ADA Curb Ramp New Construction Inspection Form (Perpendicular)

Nw 289

24952.54

Nw union

PERPENDICULAR RAMP (PR)

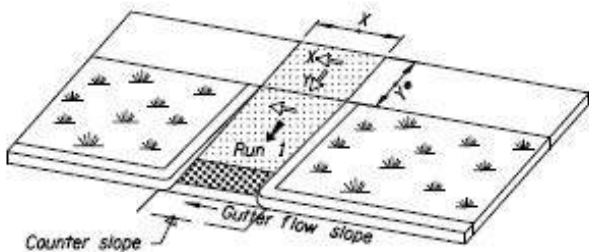
ICRR RR1 fail
